## Phase 1 School Lindfield Learning Village Eton Road, Lindfield

## Appendix 2 Response to Submissions

Appendix 2 is a summary of issues raised by Ku-ring-gai Council of 9 August 2017.

# Appendix 1 Phase 1 School Floor Plan

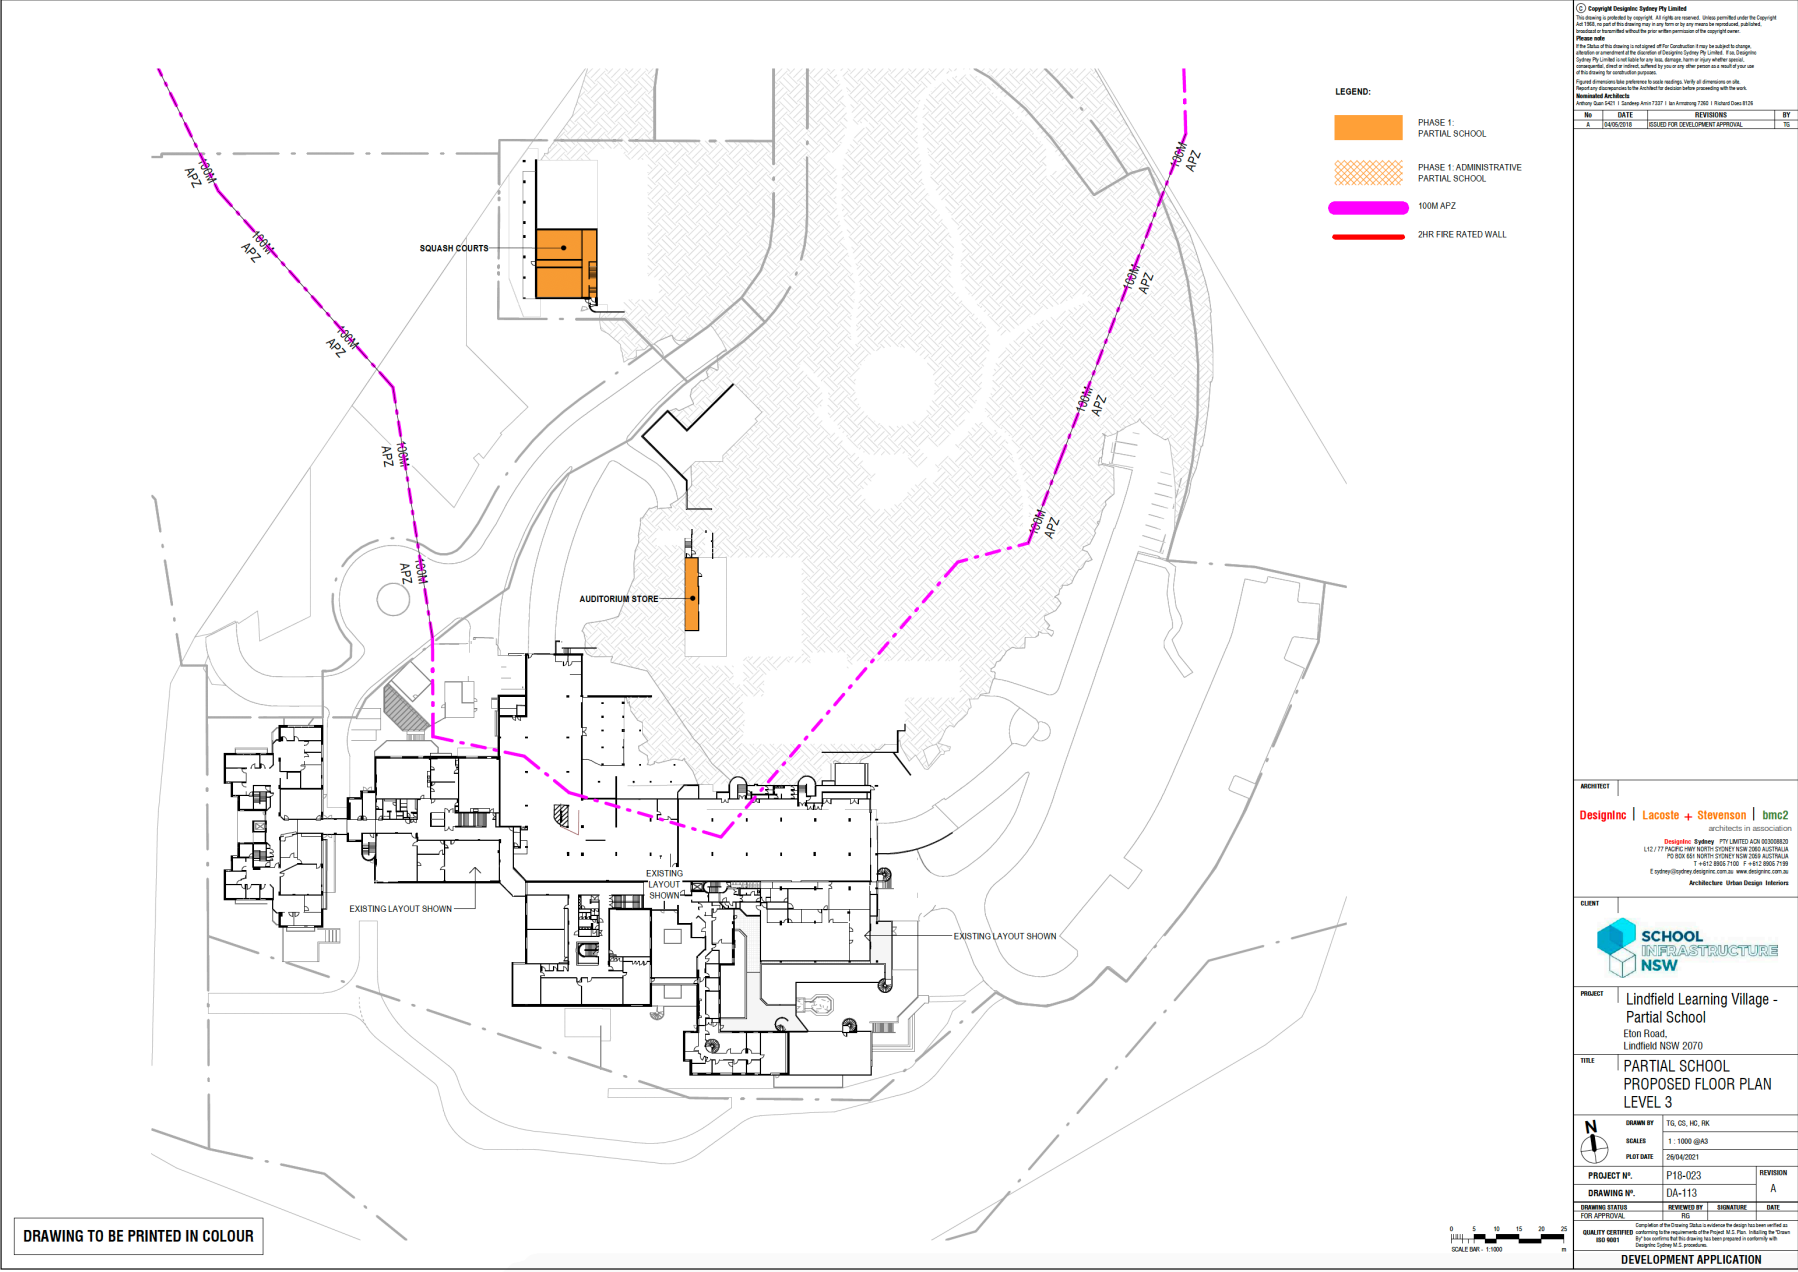
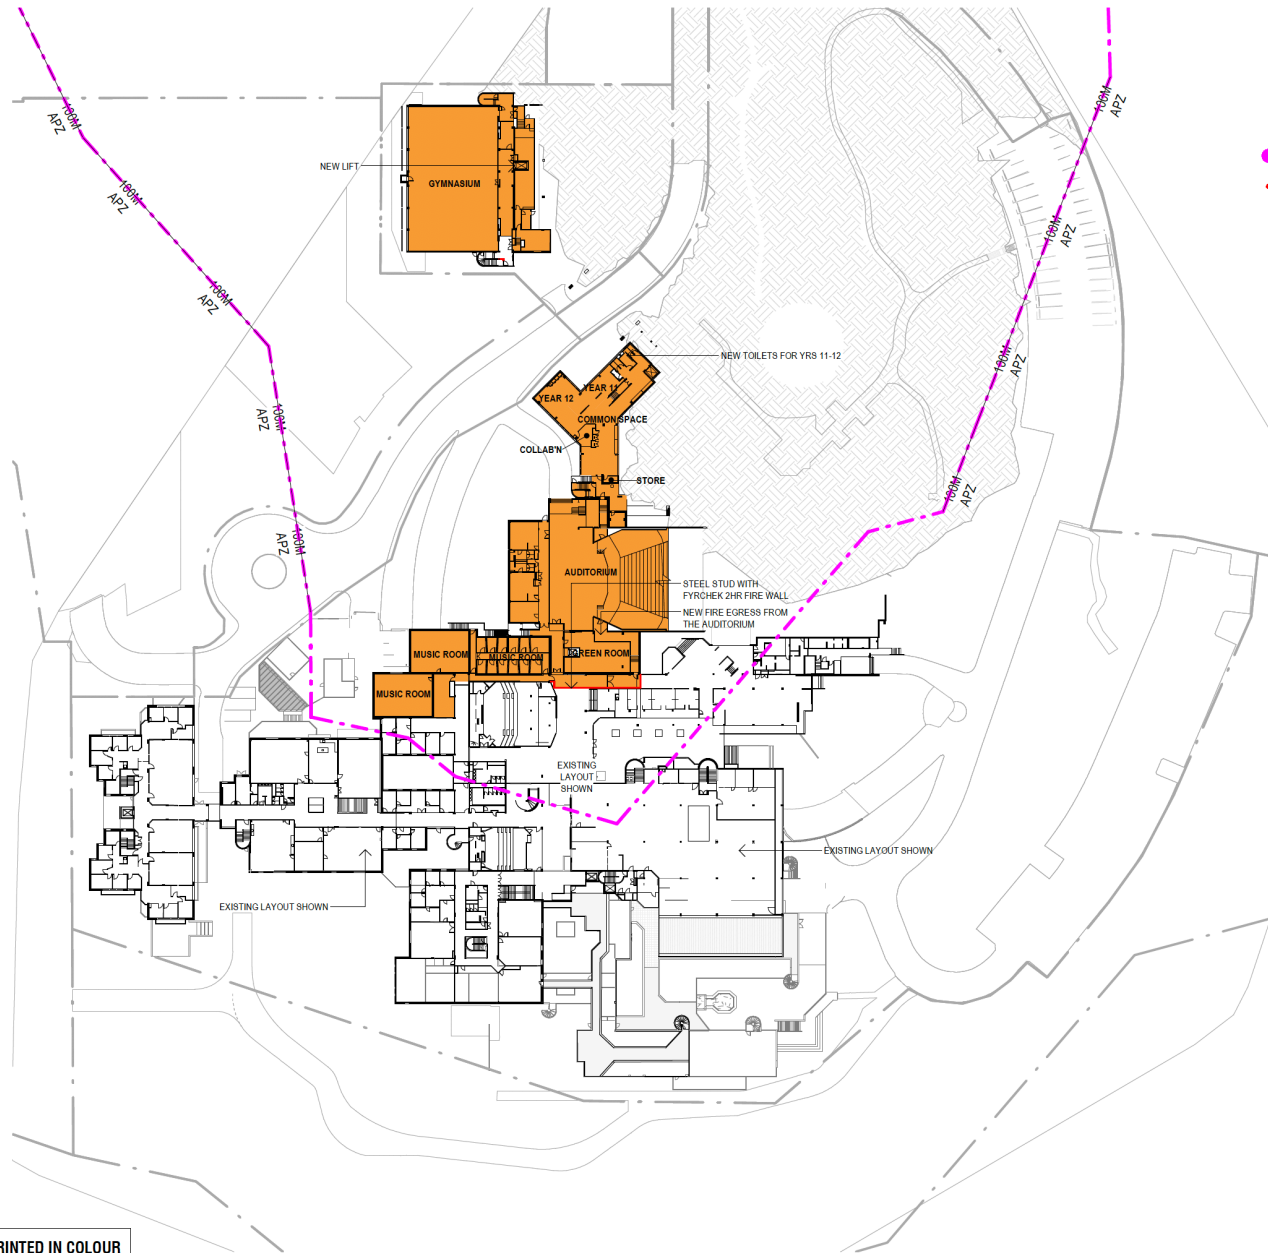
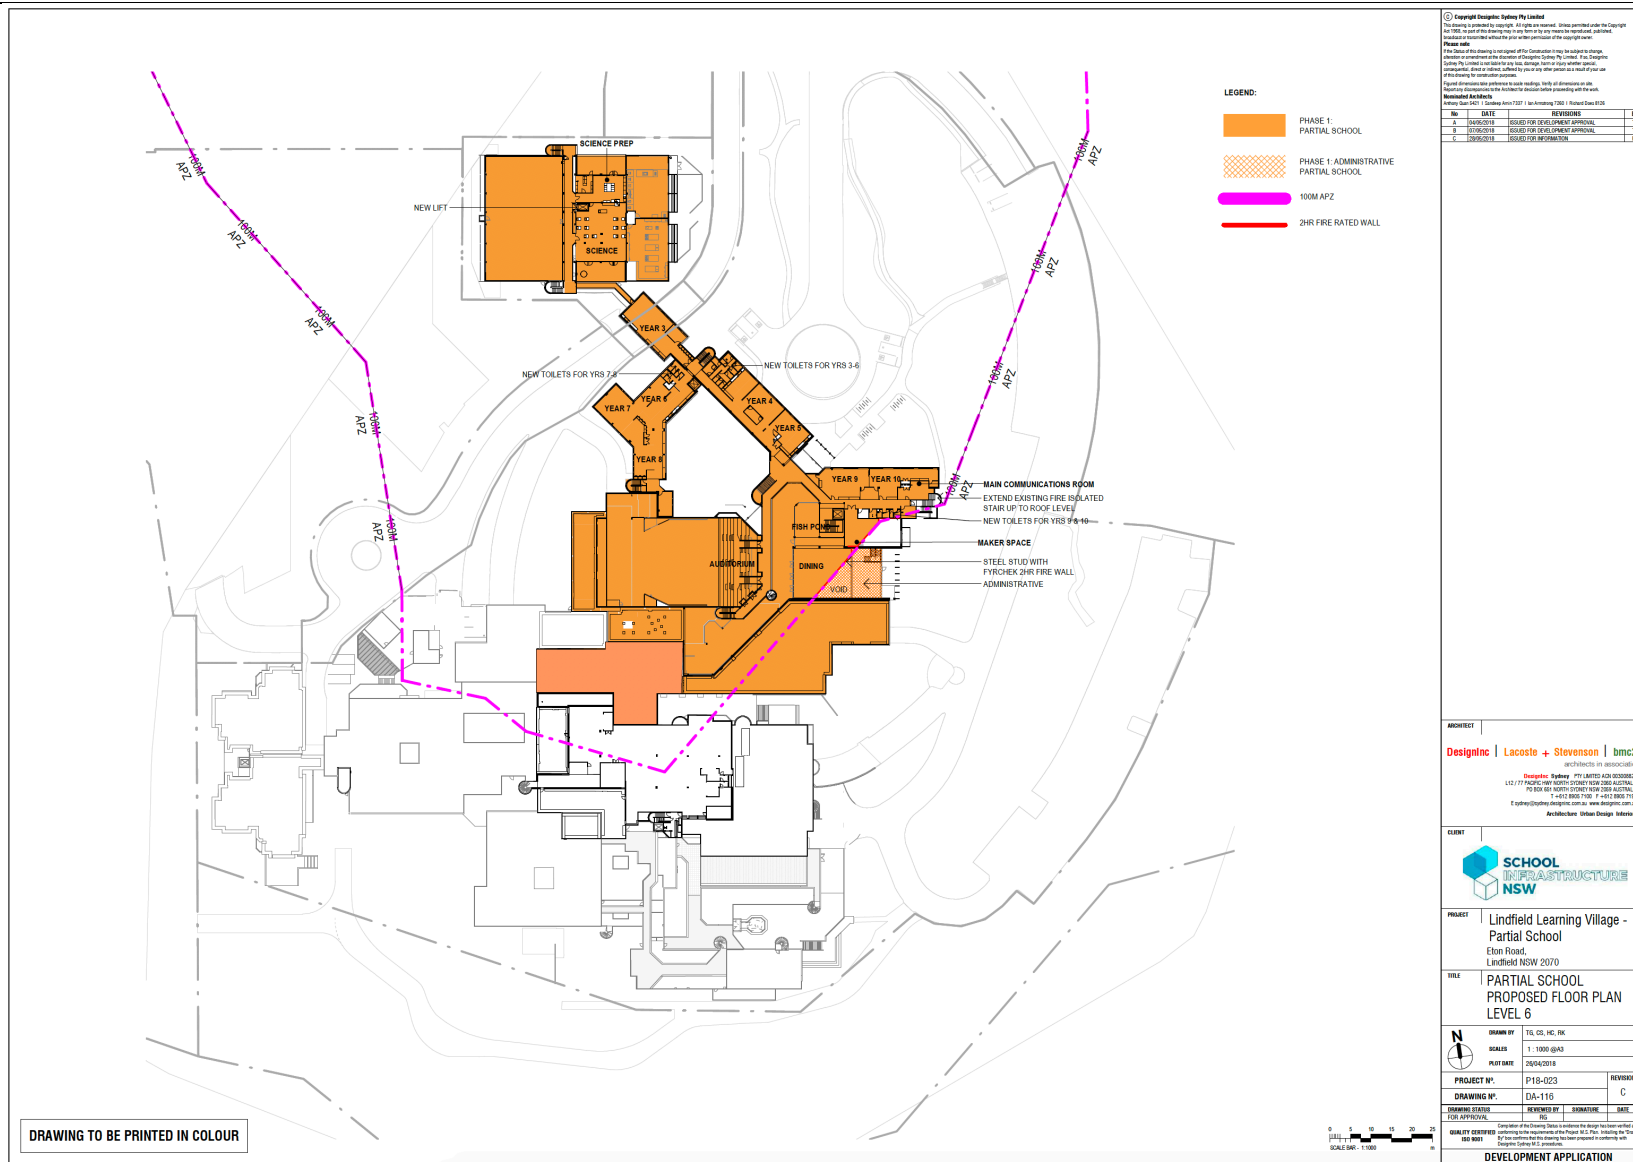
**RESPONSE: Addressed** - refer to 1.1 above and supporting Bushfire Assessment Report prepared by Blackash. The proposed Phase 1 School has been correctly captured as SFPP development, and has been subjected to all the relevant provisions and requirements in accordance with PBP 2006. These provisions include a maximum radiant heat threshold of 10kW/m<sup>2</sup> to any part of the building (particular focus on all relevant entry/exit points) and a modelled flame temperature of 1200 degrees Kelvin - the primary output of which would be increased separation distances / APZs from the hazard. Deemed to satisfy APZs from PBP 2006 have been applied to the Phase 1 School that provide a separation from the hazard of 100 metres.

Some of the existing buildings may be located within the Flame Zone. However, these will not be used for the Phase 1 School or any other purpose at this stage of assessment.

The implementation of a compliant APZ in combination with performance solutions incorporating fire 'compartmentalisation' via the construction of fire-rated walls through the existing LLV building structures will provide a satisfactory outcome and are located at or below 10Kw/m<sup>2</sup> of radiant heat.
